REPLACING PAGE ADDENDUM

**KEY TELEPHONE SYSTEMS
STATION ARRANGEMENTS FOR 2- AND 4-WIRE
PRIVATE LINE SERVICE
CONNECTIONS**

1.001 This addendum supplements Section 518-610-401, Issue 3. The attached page must be inserted in the section in accordance with the filing instruction above.

Fig. 1 - Connections for 4-Wire Service - Single Line Telephone Set

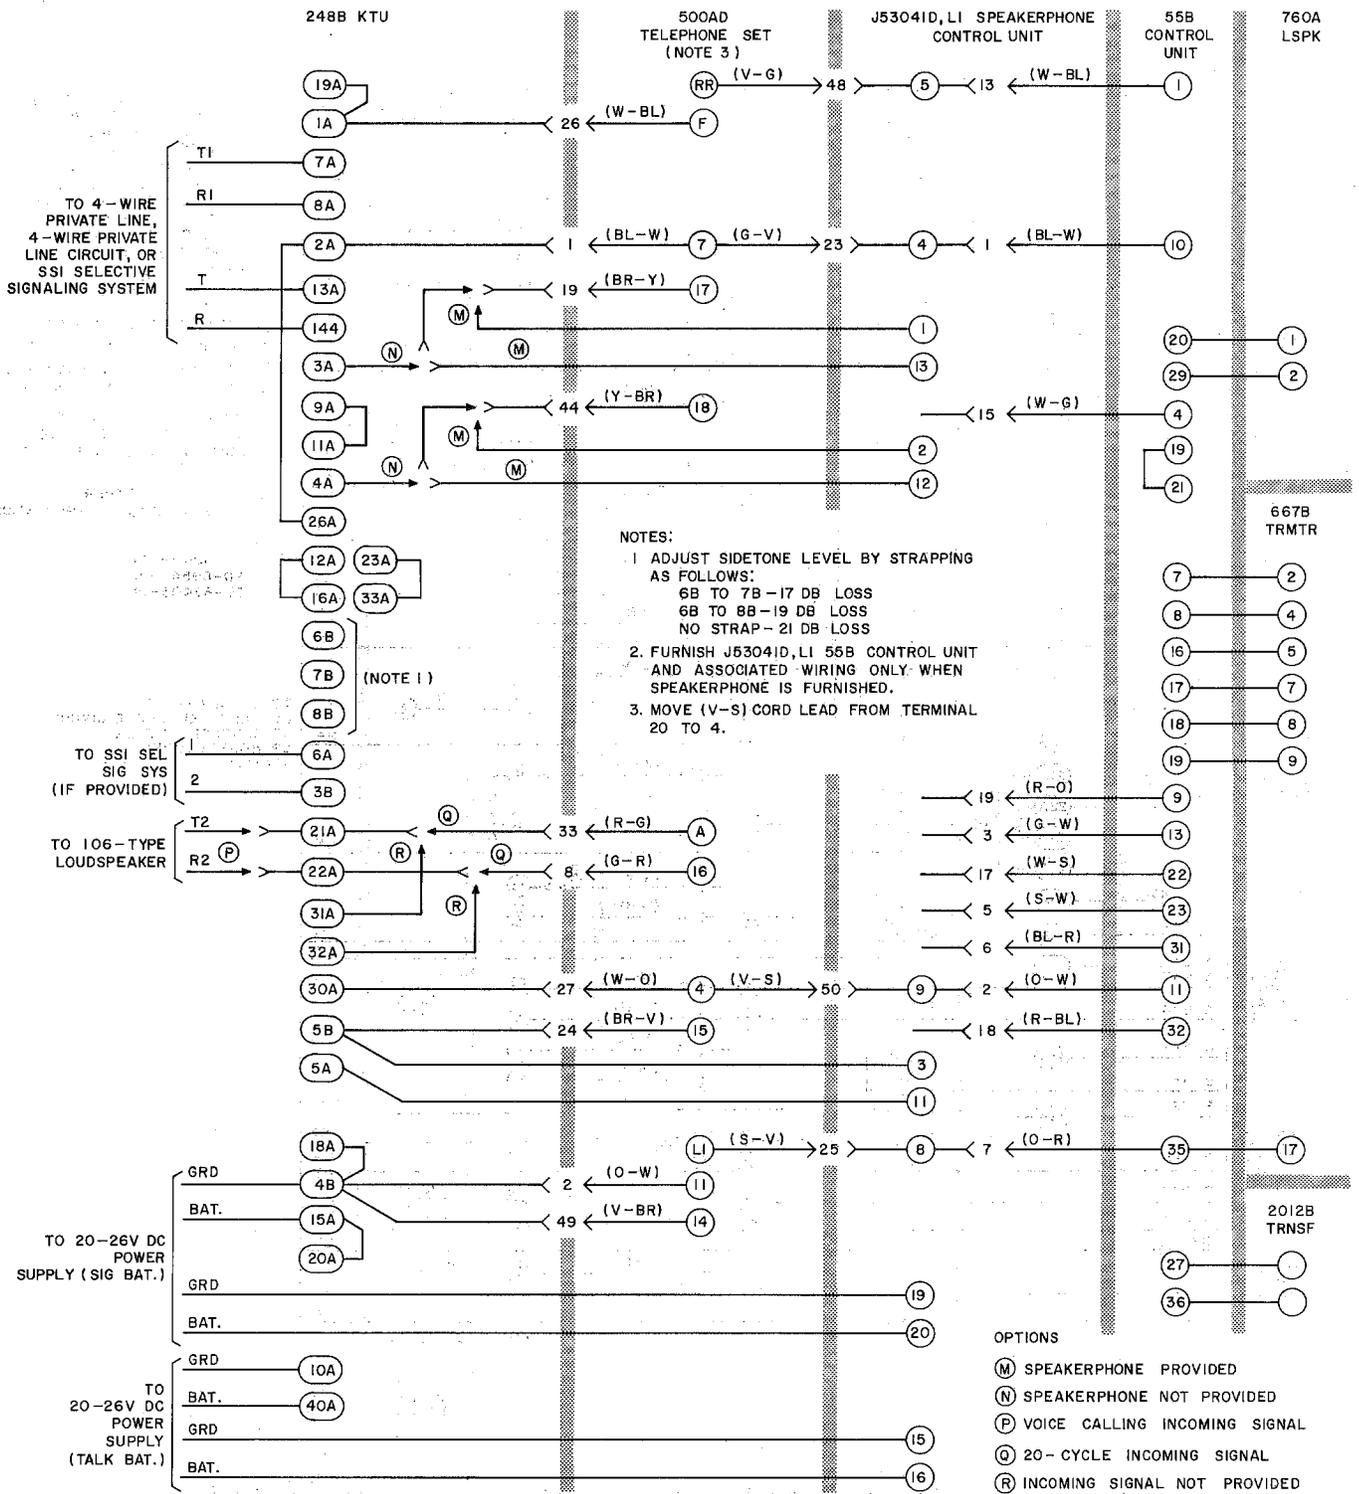
1.002 This addendum is issued to correct strapping of 248B KTU shown in Fig. 1.
